## **CORRIGENDUM - 1**

**Work Descriptions:** Request for Proposal (RFP) for Installation and Commissioning of Automated Multilevel Car Parking System at 4 (four) locations in Bhagalpur, Bihar under Smart City Mission on EPC Contract.

**NIT No. -** BSCL/Multilevel Car Parking/2021/66 dated 07/07/2021.

Prebid queries response for Installation and Commissioning of Automated Multilevel Car Parking System at 4 (four) locations in Bhagalpur, Bihar under Smart City Mission on EPC Contract.  
NIT No. - BSCL/Multilevel Car Parking/2021/66

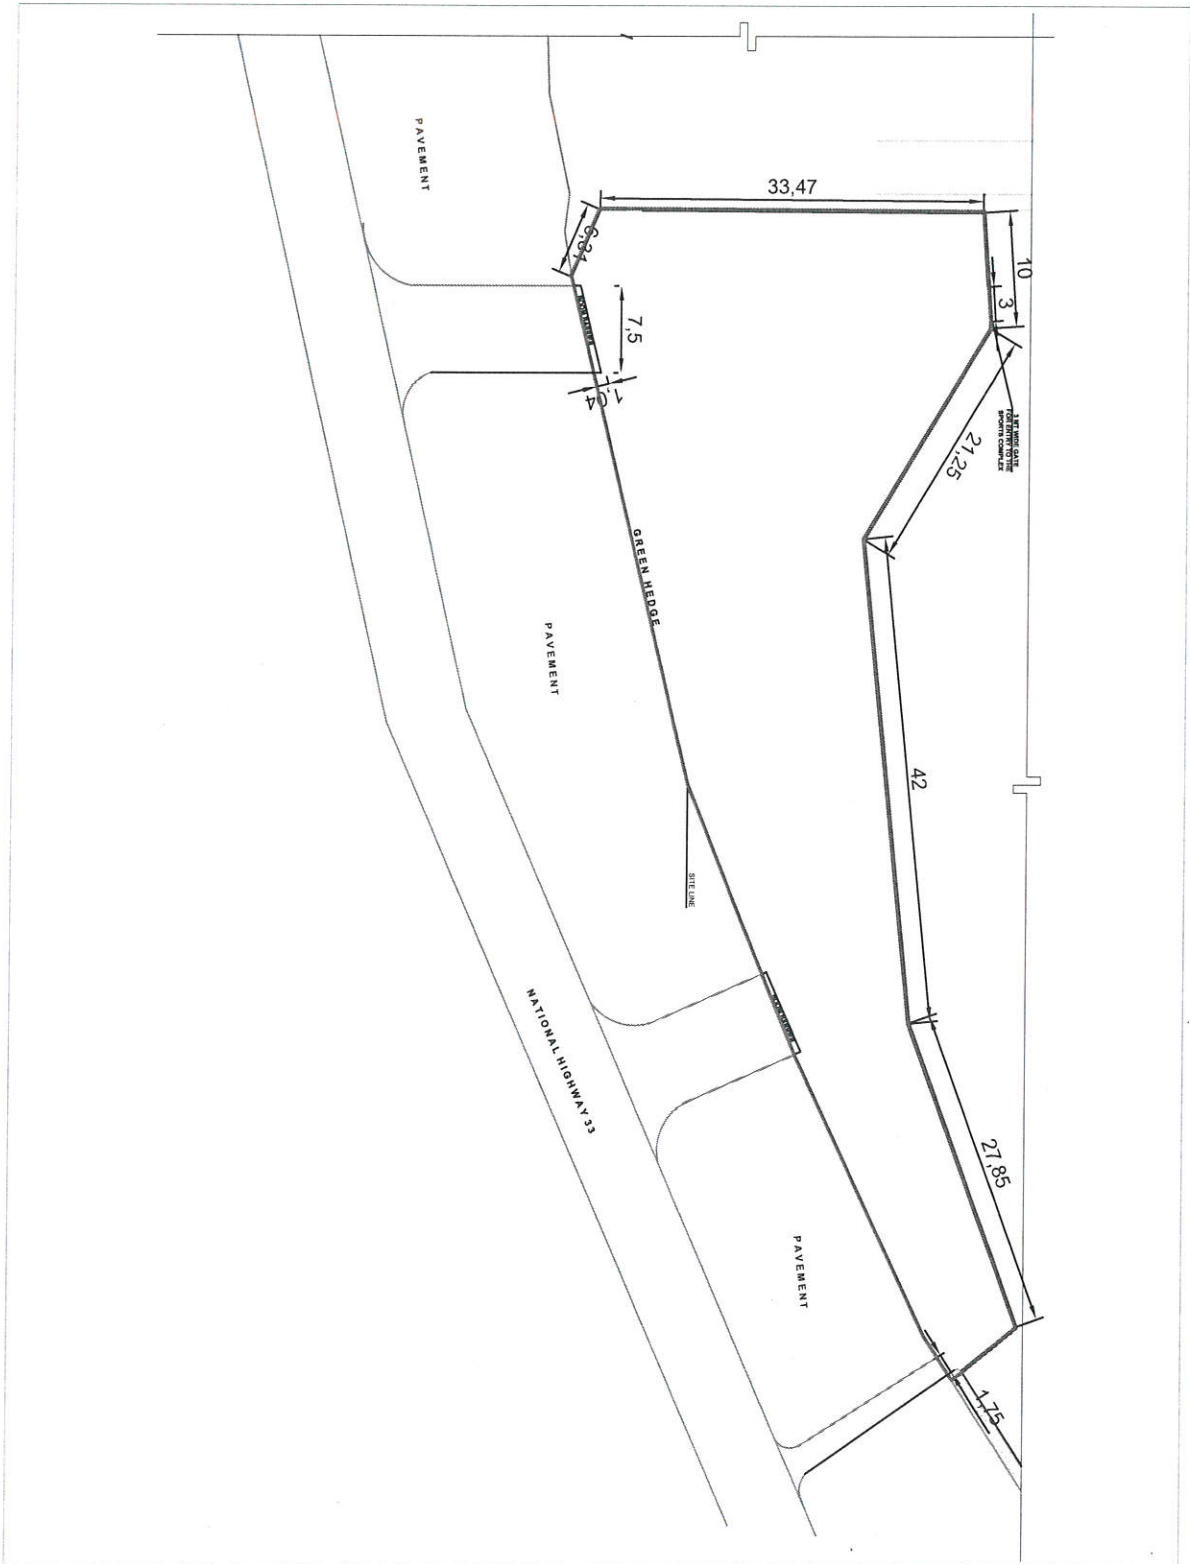
6	22	4. 4.3. e	Experience in similar works means: - works of Design, Manufacturing, supply, installation, testing and commissioning of multilevel electro mechanical car parking of minimum 3 or more stories.  Or  The firm should have completed at least one work of 3 years continuous omprehensive maintenance and operation of multilevel electro mechanical car parking of minimum 3 or more stories.	Ammended as below: Experience in similar works means: - works of Design, Manufacturing, supply, installation, testing and commissioning of multilevel electro mechanical car (four wheeler) and bike (two wheeler) parking of minimum 3 or more stories.  Or  The firm should have completed at least one work of 3 years continuous omprehensive maintenance and operation of multilevel electro mechanical car (four wheeler) and bike (two wheeler) parking of minimum 3 or more stories.	Accepted.
7	13		Drawings & Design	Kindly provide us the drawing in Autocad Format to enable us to prepare layout and check feasibilty of putting the system accordingly	Drawings are enclosed as annexure - 2.
